RE: Martin Project, FERC No. 349 and Yates and Thurlow Project, FERC No. 2407

Alabama Power is requesting FERC approval for a drought-based temporary variance to the Martin Project rule curve, which is described as follows;

Attachment 1

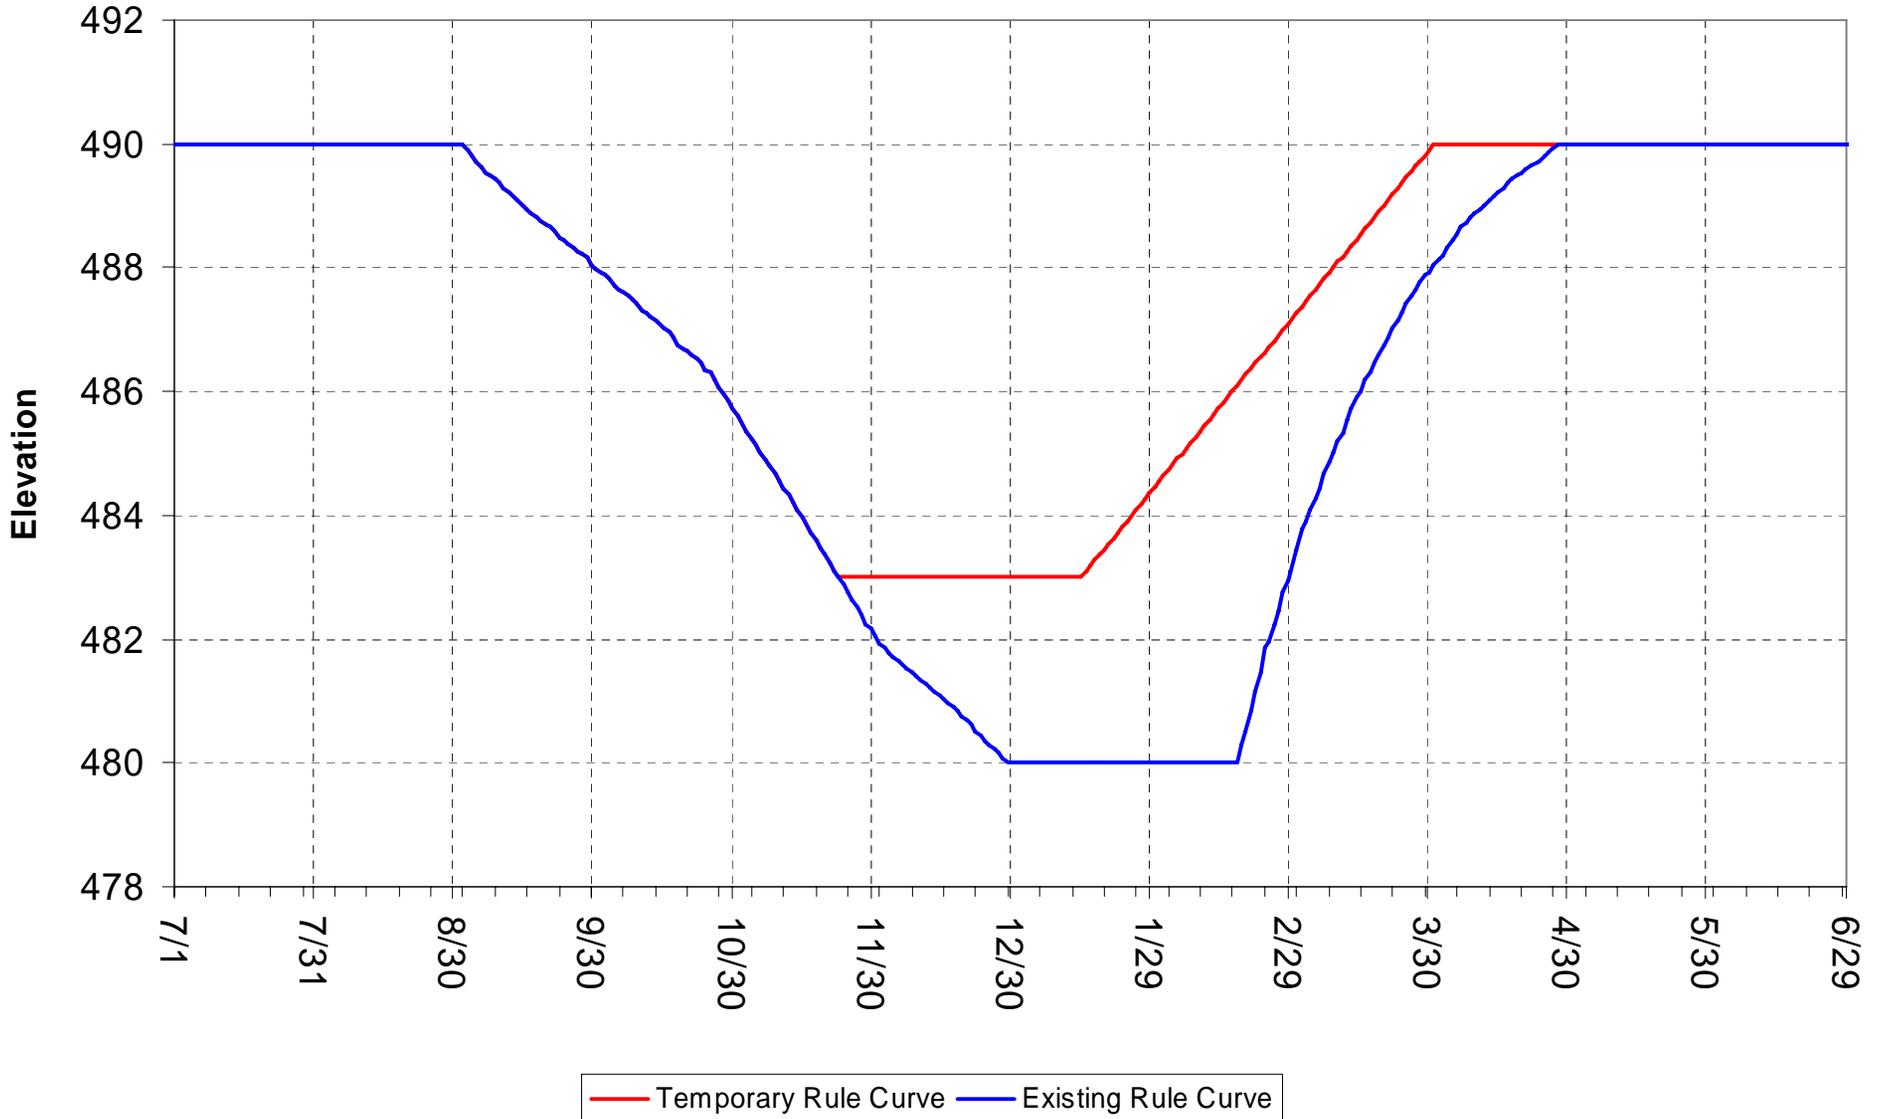
1. Maintain the winter pool elevation 3 feet higher than normal, at El. 483 instead of El. 480.
2. Begin maintaining the winter pool elevation earlier than normal, on November 20th rather than January 1st.
3. Initiate the filling process earlier than normal, beginning January 15th instead of February 15th.
4. Reach and maintain summer pool elevation earlier than normal, on April 1st rather than May 1st.

Attachment 2

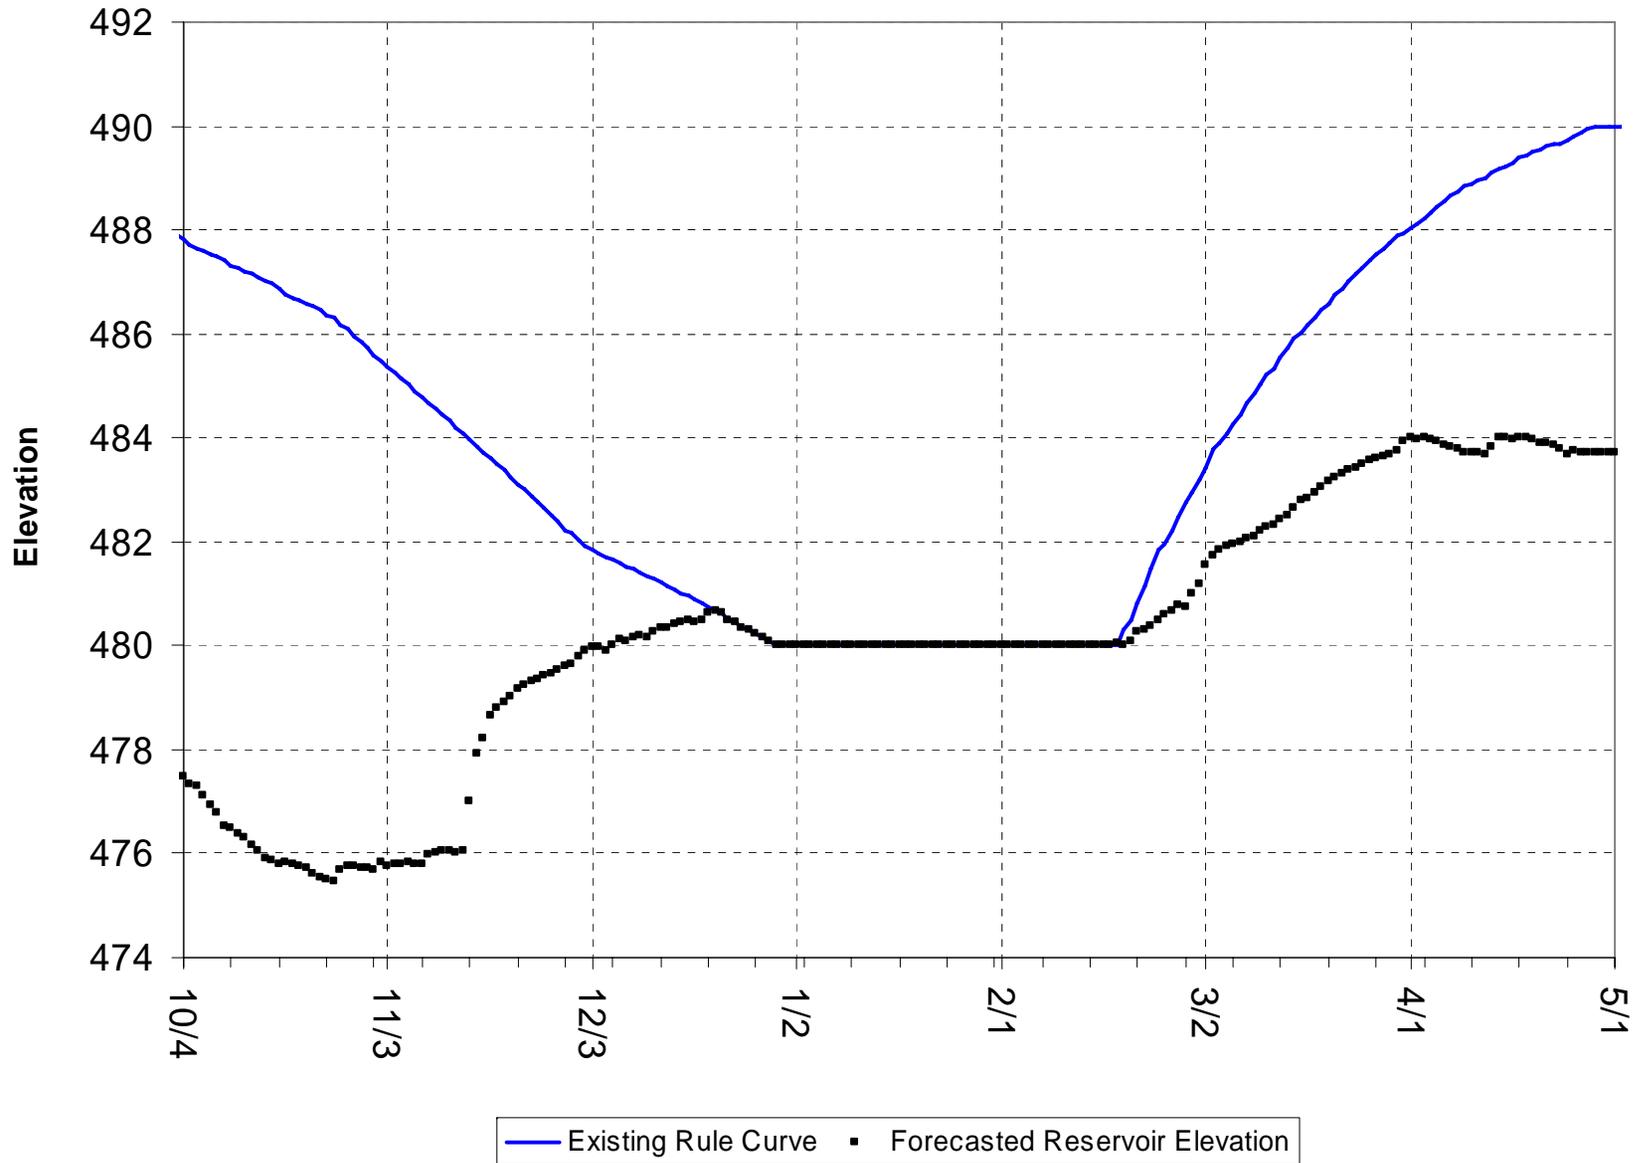
This variance request is shown graphically on the enclosed Attachment 1. Also enclosed are graphs depicting the projected Martin Reservoir elevations from modeling runs made without the rule curve variance (Attachment 2) and with the variance (Attachment 3). The projections depicted in these attachments are based on actual inflows from 2006 and 2007, with two significant rain events dampened to reflect the unfavorable rainfall forecasts and a continuation of the severe drought conditions. As Attachment 2 clearly shows, in the absence of the variance, Martin Reservoir is expected only to reach El. 484, which is six feet below the normal summer pool elevation. As seen on Attachment 3, with the rule curve variance in place, there is a good possibility that Martin Reservoir could reach summer pool by early April, which would greatly enhance Alabama Power's ability to support the many reservoir and downstream needs during next summer's critical period.
